Office Action Summary	Application No. 10/717,843	Applicant(s) MEHROTRA ET AL.	
	Examiner José R. Díaz	Art Unit 2815

DETAILED ACTION

2. Claims 14-23 are rejected under 35 U.S.C. 102(e) as being anticipated by Maeda et al. (US Pat. No. 6,424,010 B2).

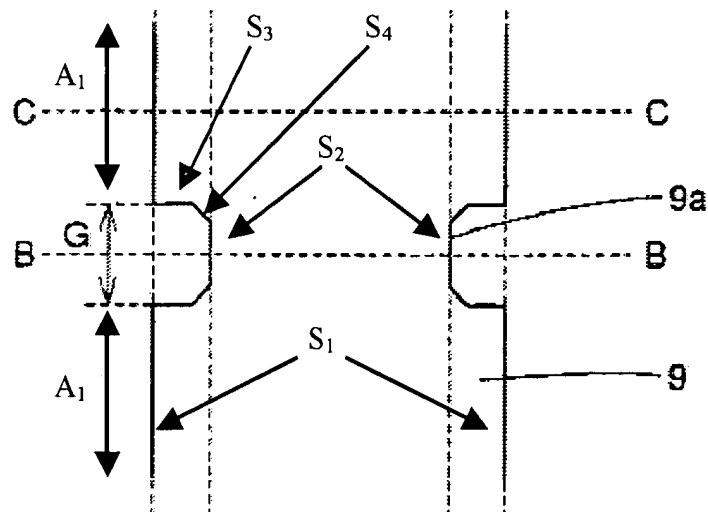
a gate electrode (9) extending along the surface for a length (see fig. 22A), the gate electrode (9) having at least one second section (9a) disposed between adjacent ones of the first sections (9) of the gate electrode (see fig. 22A), the at least one second section (9a) having a width that is narrower than the width of the adjacent ones of the first sections (9) of the gate electrode (see fig. 22C); and

source and drain doped regions (5a1 and 5b1) in the surface, and disposed on opposing sides of the gate electrode (see figs. 22A-22B).

FIG. 22A

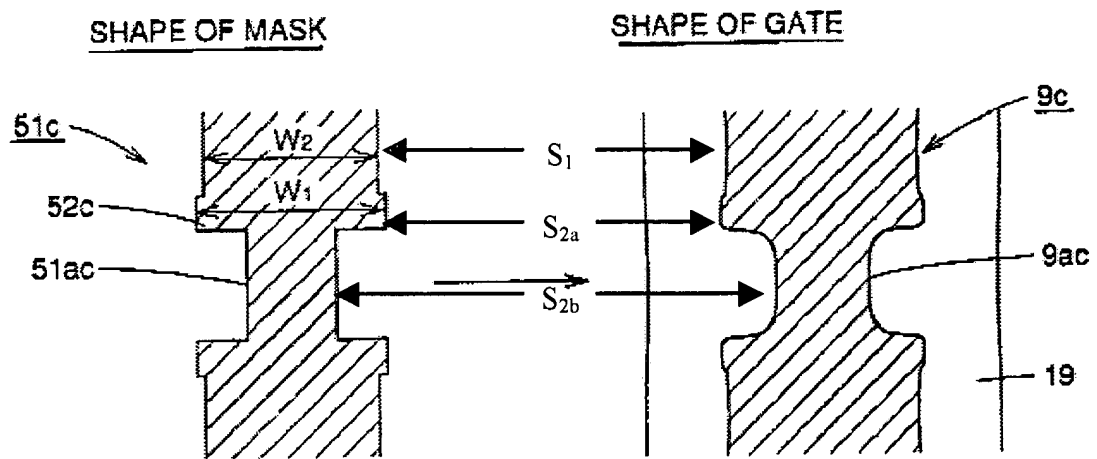
Regarding claim 17, Maeda et al., as far as understood, teaches a device in which the length of the second section (G) is smaller than the length of the first section (A₁) (see figure 22A, below). In addition, the claimed limitations describing the elongated feature of the photoresist contain method of process of making

Regarding claim 18, Maeda et al., as far as understood, teaches that the sides of the second section (S_2) are parallel to the sides of the first sections (S_1), and a side (S_3) formed between first and second sections, which is substantially perpendicular to the sides of the first and second sections (S_1 and S_2) (see figure 22A, above). In addition, the claimed limitations describing the elongated feature of the photoresist contain method of process of making characteristics, therefore given no patentable weight in determining patentability of the final device structure. See case law above.

Regarding claim 20, Maeda et al., as far as understood, teaches that the sides of the second section (S_2) and its adjacent ones of the first sections (S_1) are separated by slopping portions (S_3 and S_4) (see figure 22A, above). In addition, the claimed limitations describing the elongated feature of the photoresist contain method of process of making characteristics, therefore given no patentable weight in determining patentability of the final device structure. See case law above.
